Line Audit Report

Huihe PET Line Audit Report

Fill height Variations.

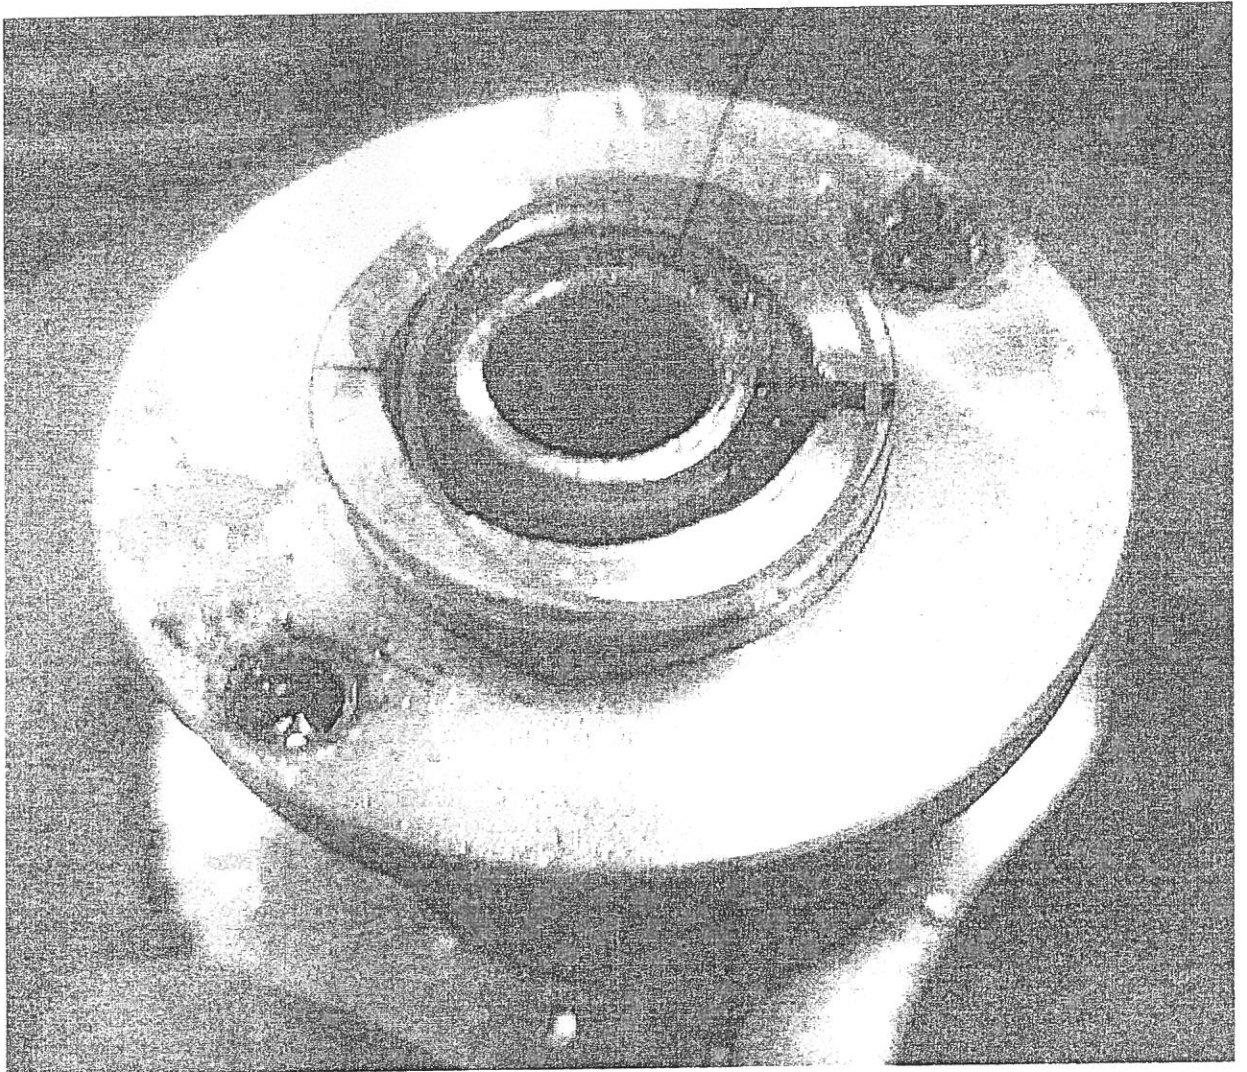
Causes:

Damaged rubber seals, resulting in product leakages.

The damaged rubber seals need to be replaced with new ones to eradicate product leakages and losses.

Damaged rubber seals on the filling valves.

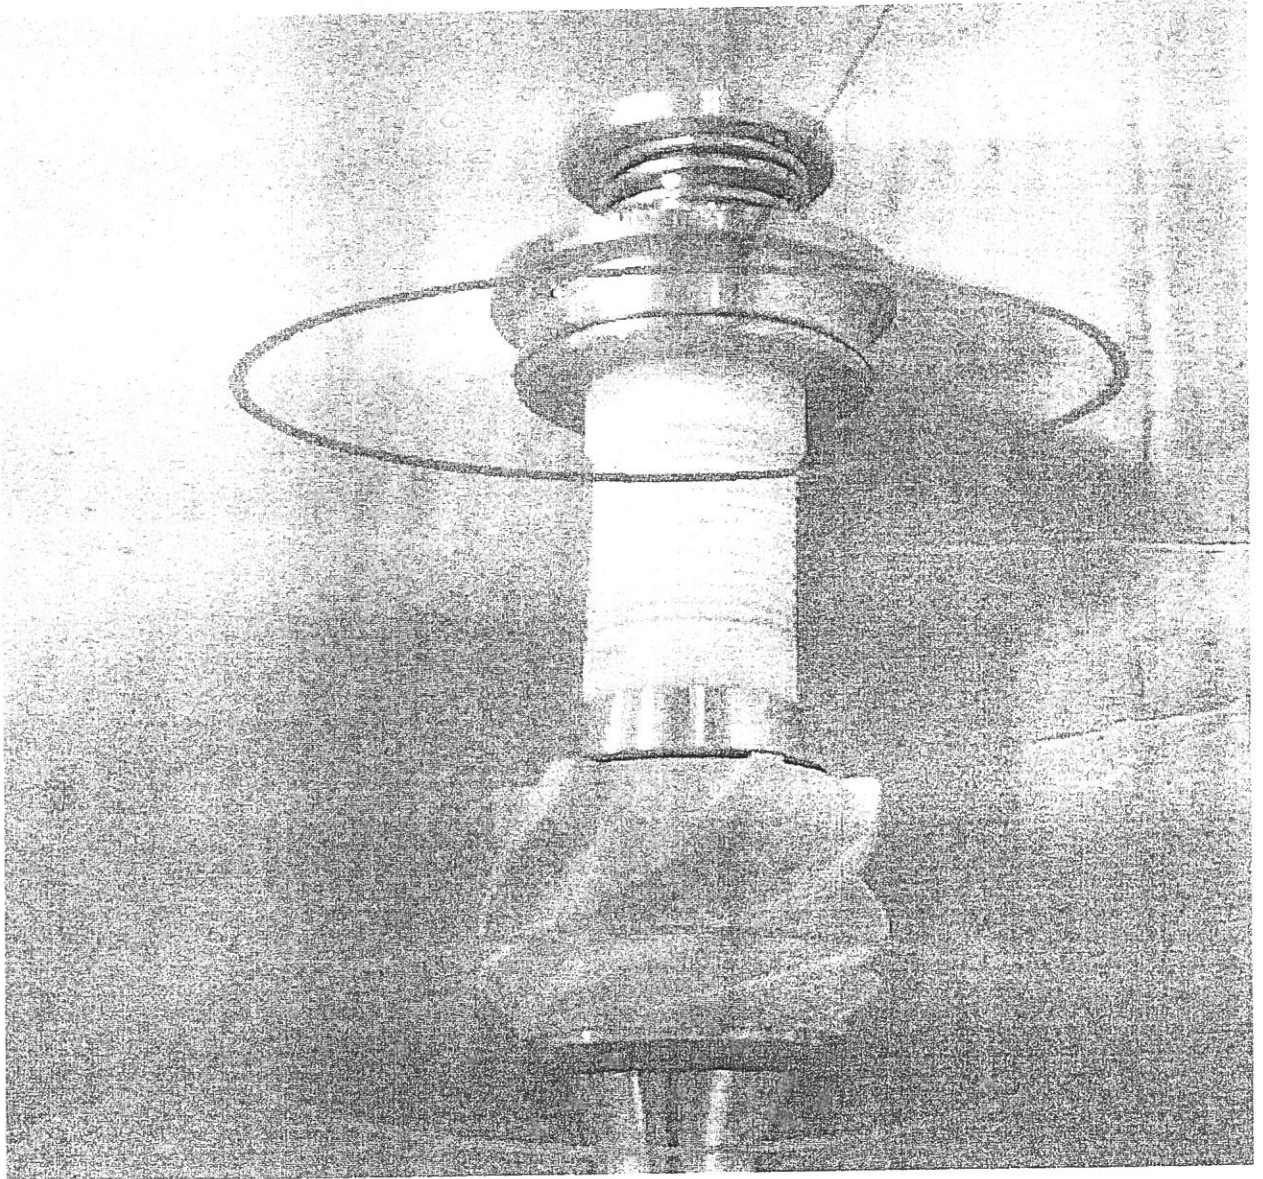
These need replacements in correct positions to eliminate product and CO2 leakages.

Required> overhaul of all filling valves and filling heads

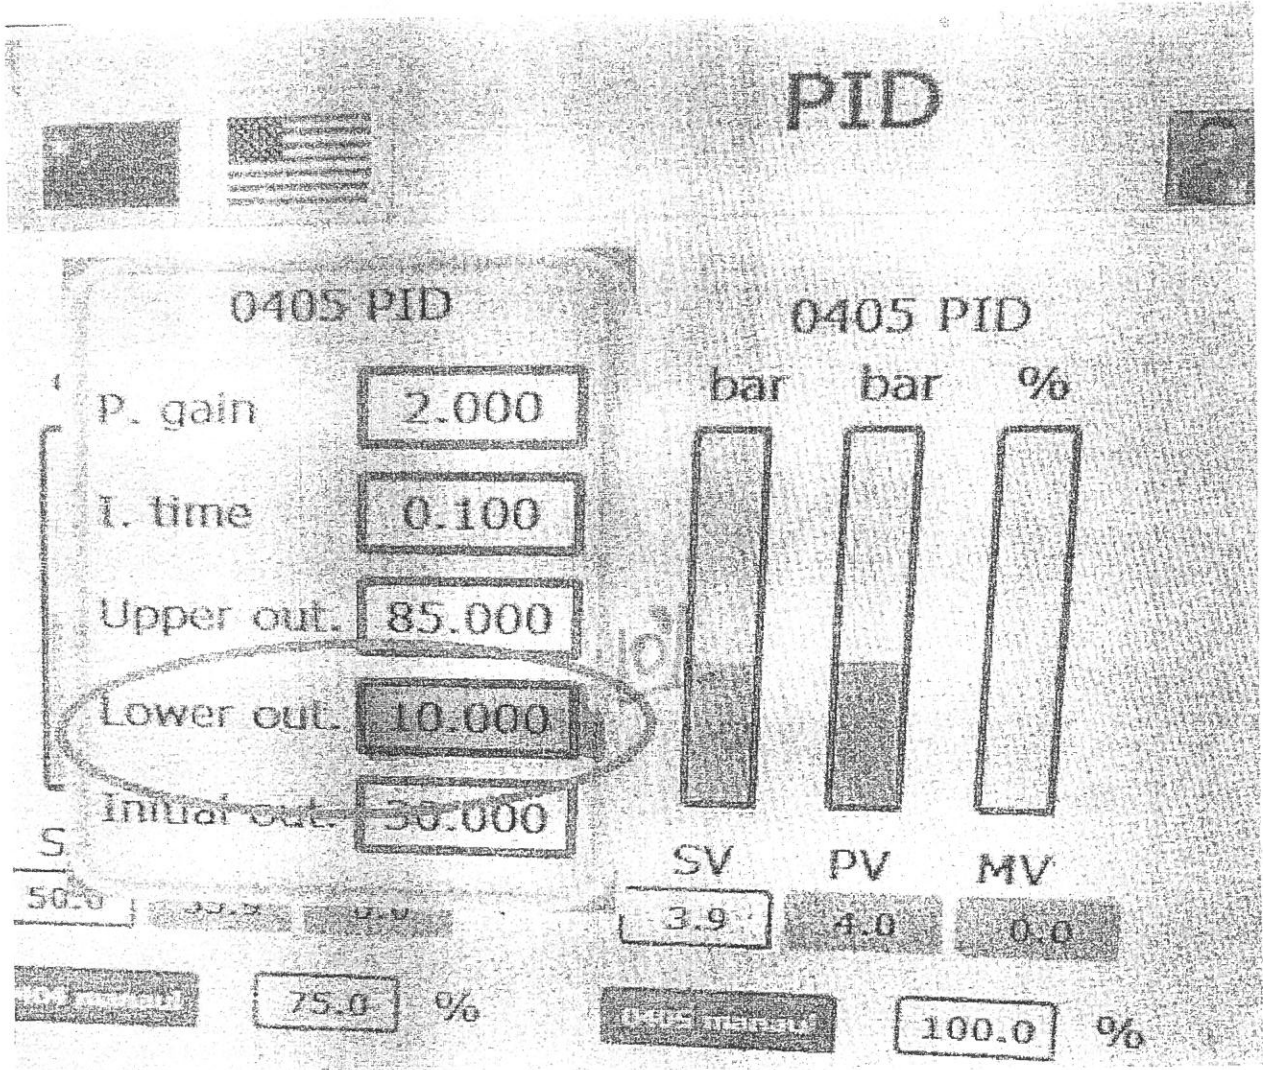
The lower limit of the PID loop was observed to be fixed at 10% at all times, resulting in continuous injection of CO₂ into the buffer tank and hence over/carbonation. This should be reprogrammed to allow for effective closing and elimination of CO₂ losses.

we cannot reduce too to 0
Not acceptable
